Project Title : WALGREENS CLINIC RENOVATION

City of Aurora Plan Review

NO.	DATE	BY	DESCRIPTION	CONST.
1	01-26-09		PERMIT RESPONSE: WALGREENS REVIEW #1

COVER SHEET

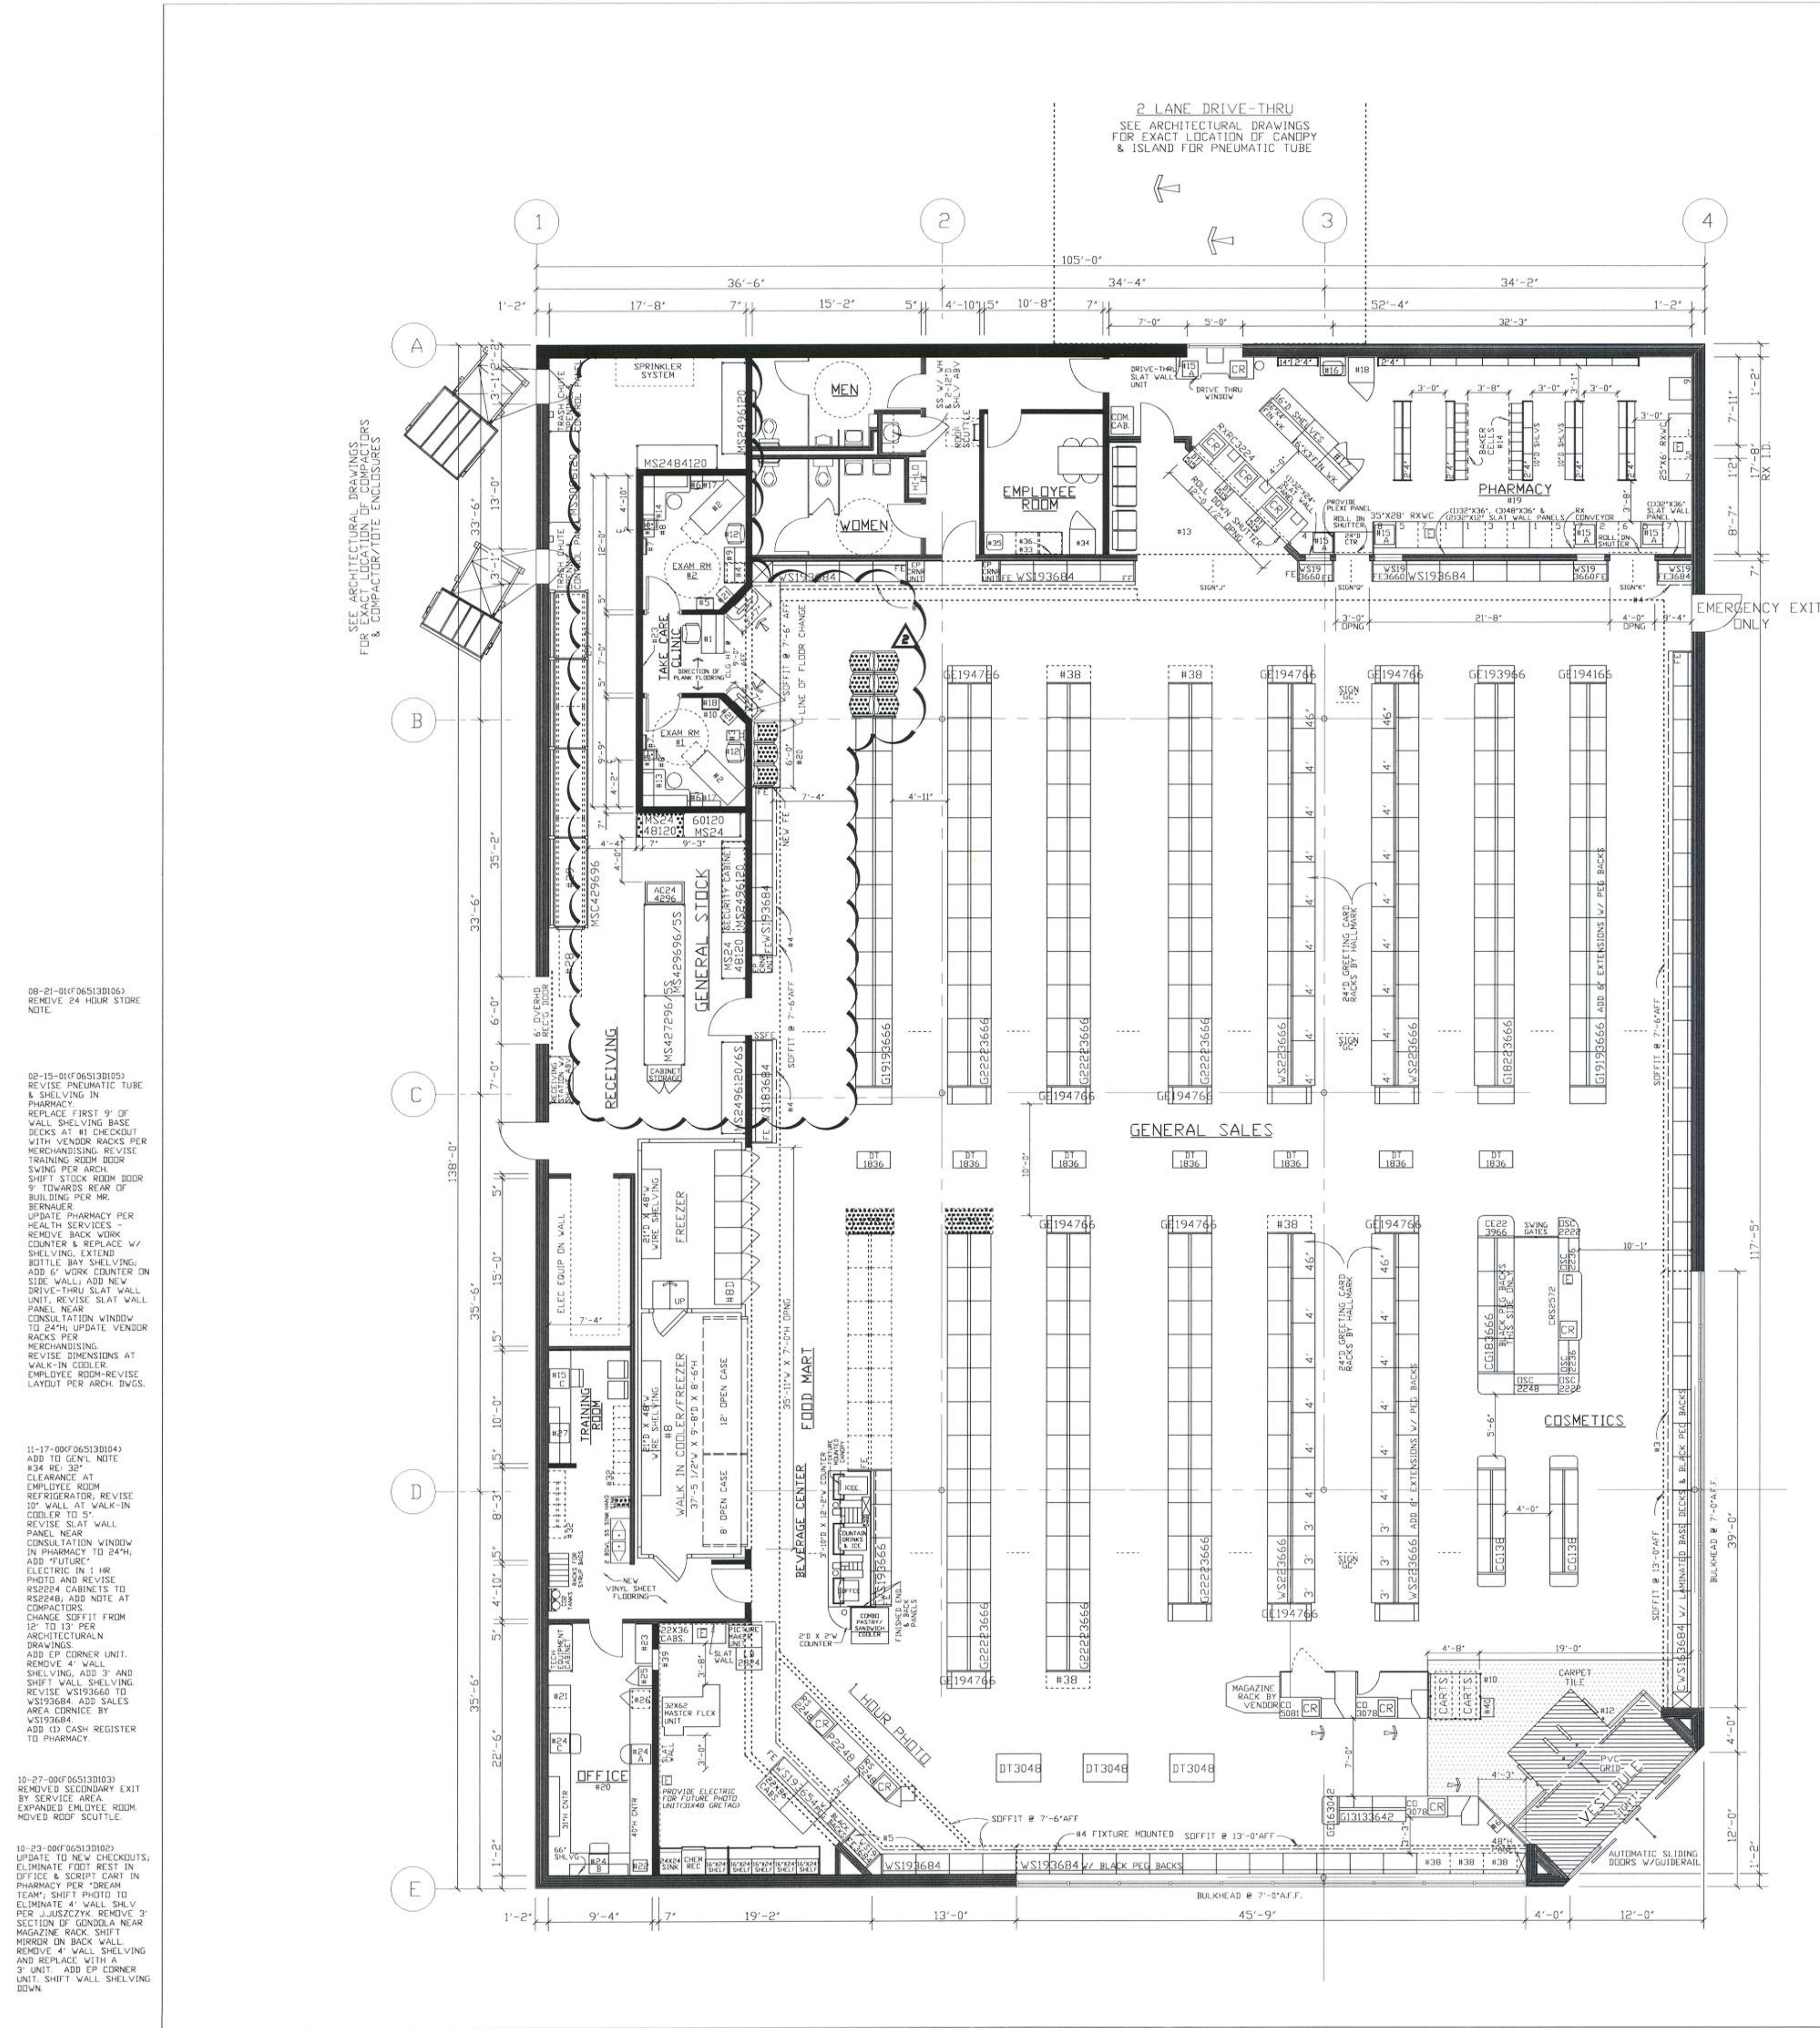
Provide U.L. Class 3A V.B.C. minimum rating fire extinguishers at a maximum 75'-0" travel distance prior to the Certificate of Occupancy issuance (2006 IFC Table 906.3(1) and 2005 NFPA 10)

Consultation for fire extinguisher placement is available upon request. Call 303-739-7420 prior to final Life Safety inspection to verify proposed locations.

These plans are not reviewed or approved for compliance with A.D.A. For federal accessibility requirements contact the Justice Dept. 1-800-949-4232

Provide lever or other approved hardware on all new or relocated doors per 2003 ANSI A117.1.
